TITLE: Triple_Axis_Accelerometer_-_Gyro_Breakout_-_MPU-6050

Design by: J. Bartlett
 Revision By: E. Orosel

REV:
 v12

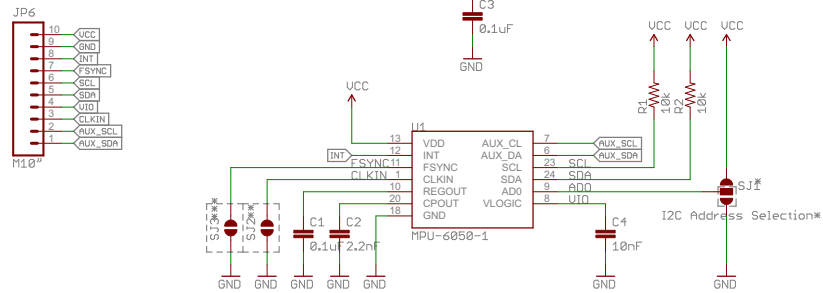
Changes to U11
 SCL and SDA were switched on U10, fixed on U11
 Broke out VLOGIC line
 C2 was mislabeled as 10nF, should have been 2.2nF.
 Added selectable jumpers to CLK, FSYNC and AD0
 Minor layout changes
 Played around with IC footprint.
 Added 4 small tcream squares to middle pad.
 Rounded and elongated pads.

BOM changes
 YES
 C2 is now 2.2nF instead of 10nF

Changes to U12:

* Two MPU-6050s can be connected to the same I2C bus
 The LSB bit of the 7 bit address is determined by the logic level on pin AD0.
 Default Address = 0x68 (pin AD0 is logic low)
 Alternative Address = 0x69 (pin AD0 is logic high)

** Optional external reference clock input. Connected to GND by default.
 Cut trace for external clock

*** Frame synchronization digital input. Connected to GND by default
 Cut trace for external sync
